City of Huron
Agenda for the Planning Commission/DRB
Wednesday, October 18, 2023 5:00pm.

TO: Chairman Boyle and Members of the Planning Commission
FROM: Erik Engle, Planning Director
RE: N2Y- Commercial Signage
DATE : October 18, 2023

TO: Chairman Boyle and Members of the Planning Commission
FROM: Erik Engle, Planning Director
RE: Huron Nails & Spa
DATE : October 18, 2023

TO: Chairman Boyle and Members of the Planning Commission
FROM: Erik Engle, Planning Director
RE: 511 South Main Street- New Business/Exterior Design Changes
DATE : October 18, 2023

DIMENSIONAL NON-ILLUMINATED WALL SIGN
Scale: 3/4" = 1'-0"

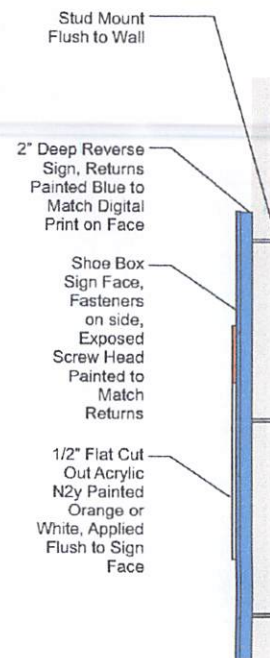
N2Y, formerly located in Huron Corporate Park, has relocated to Sawmill Parkway. They are proposing one (1) circular, dimensional non-illuminated wall sign, 5' in circumference (19.63sf) and two (2) circular digital print vinyl door graphic signs, 16" circumference (2.8sf) for their new facility.

As proposed, the 19.63sf wall sign is compliant with Chapter 1129, Appendix A: Maximum Signage Area for the I-1 District which allows for up to 120sf of max signage area. The two 2.8sf door signs are compliant and design is appropriate based on existing context.

Staff recommends approval of the commercial wall and door signs as proposed.

Huron Nails & Spa Building Sign

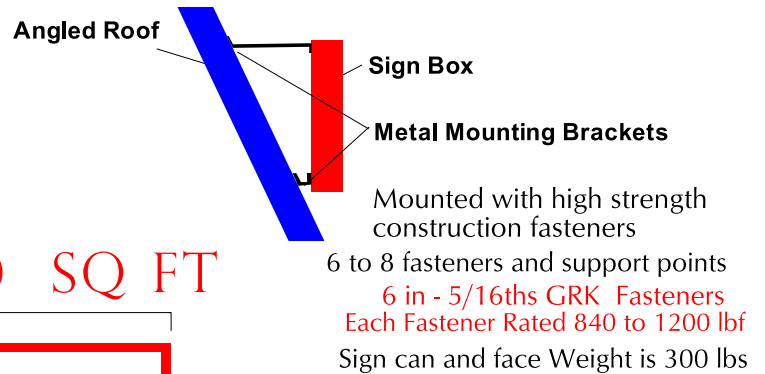
A new business, Huron Nails & Spa, going into the Shopping Plaza, is proposing a 40sf wall sign above the entrance to their unit. The sign colors are red & white, and will be LED illuminated.

The proposed 40sf wall sign is compliant with Chapter 1129, Appendix A: Maximum Signage Area for the I-1 District which allows for up to 120sf of max signage area. The unit has 20ft of store frontage and the proposed sign size is consistent with existing signs within the plaza.

Staff finds the proposed sign to be simple in design and compatible with existing adjacent signage.

Staff recommends approval of the 40sf commercial wall sign as proposed.

PROPOSED LANDSCAPE PLAN

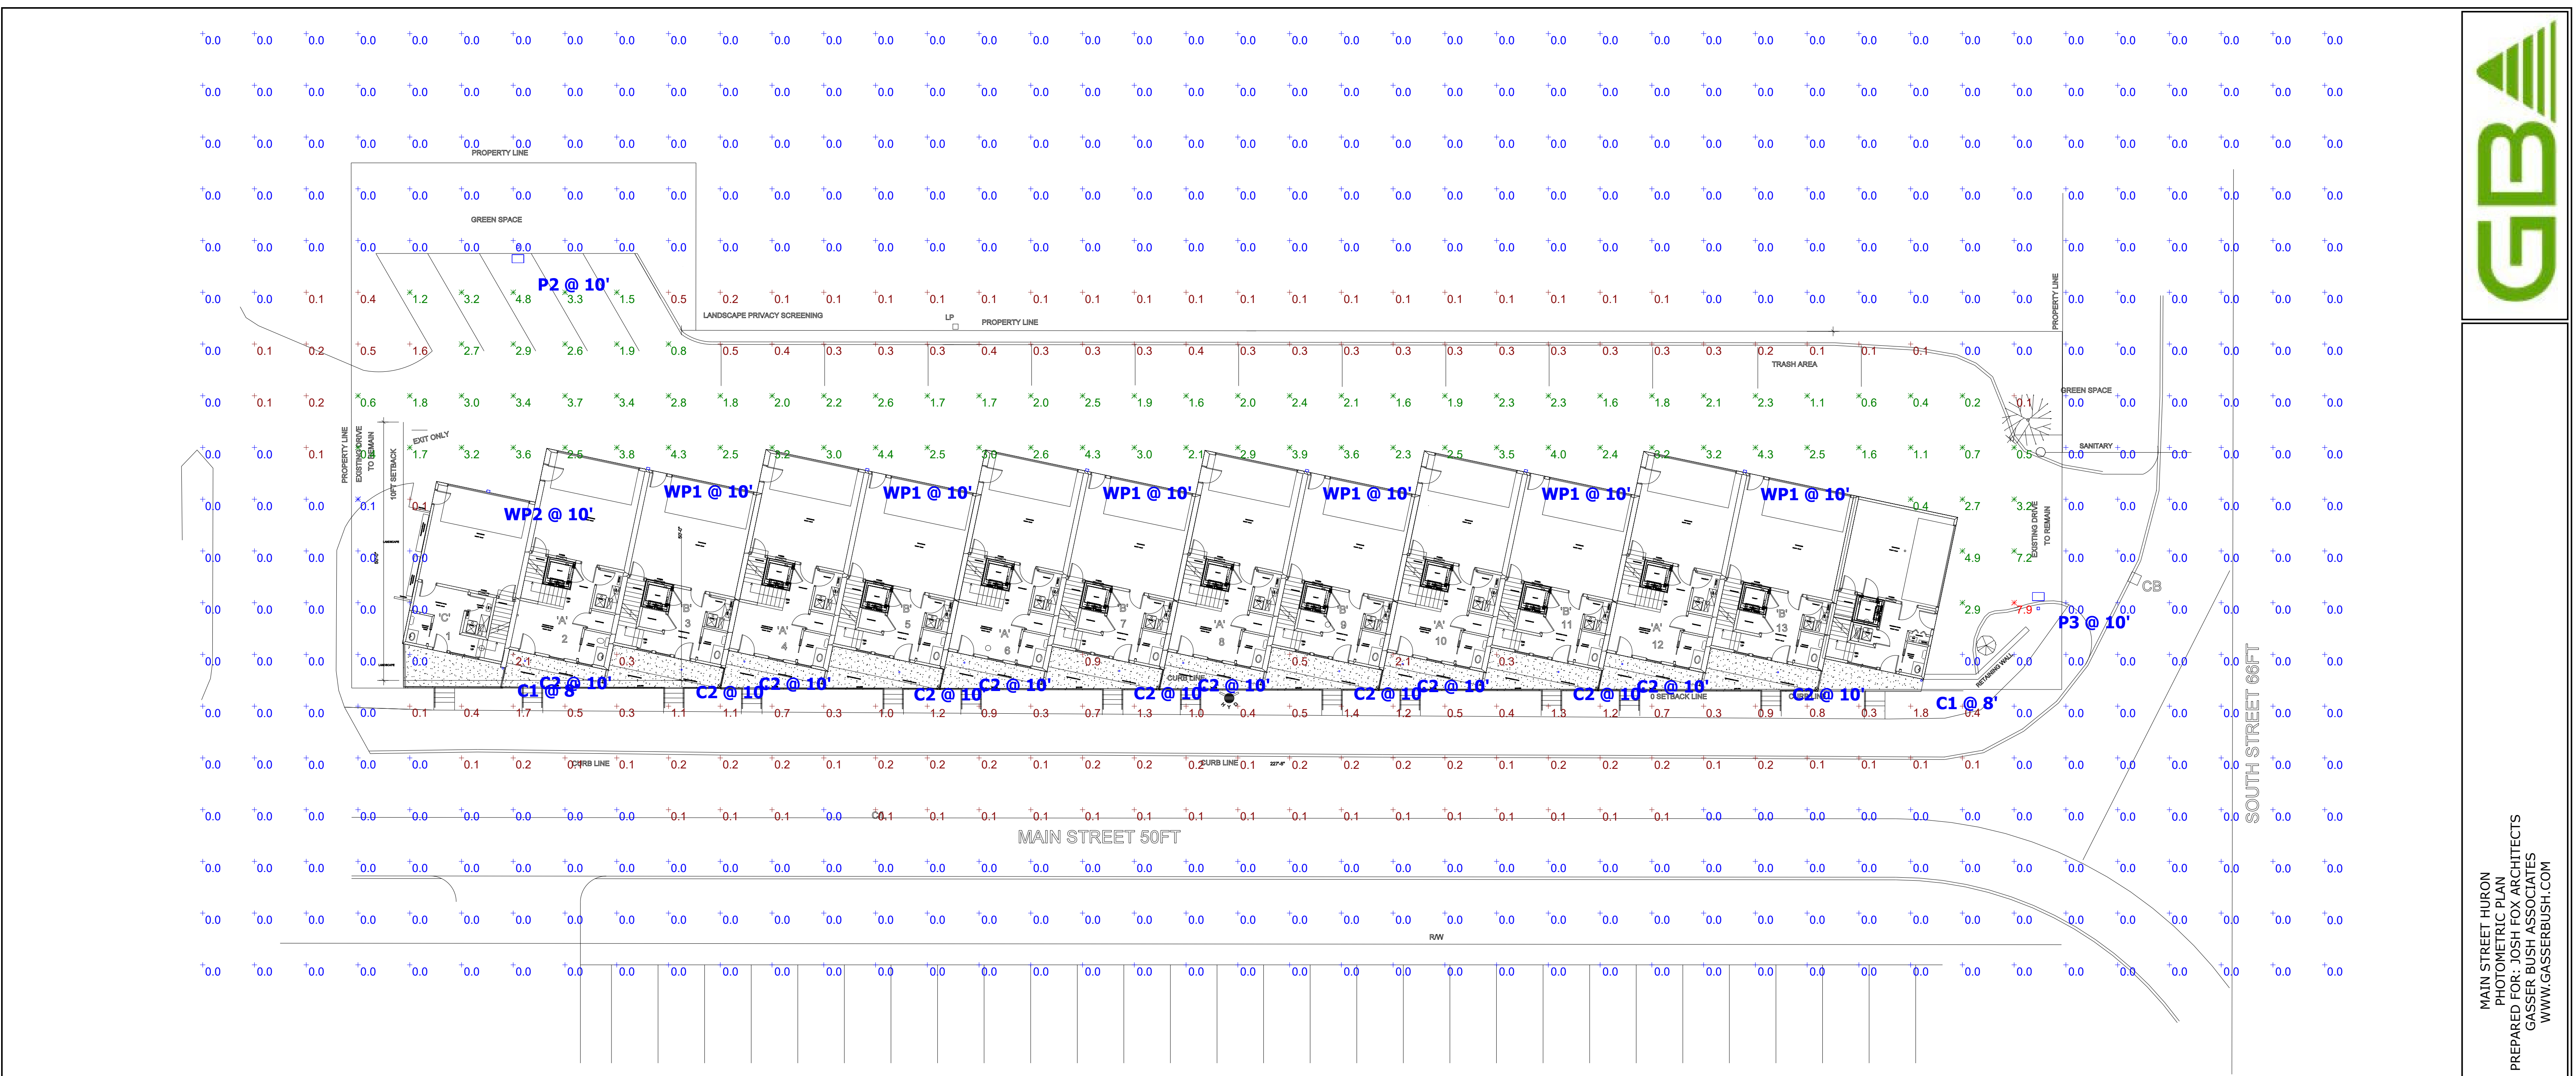
A rear buffer yard is indicated on the site plan, lined with 92 skyrocket junipers (15' ft. in height/4 ft. in width), 7 giant arborvitae (7ft. in width), and capped at the north end shared drive entrance with 2 blue spruce (7ft. in width). Ornamental hydrangeas, spirea, yew, and boxwoods will line the frontage along Main Street. Based on the number of plants indicated the landscape plan meets the minimum requirements set in the landscape ordinance.
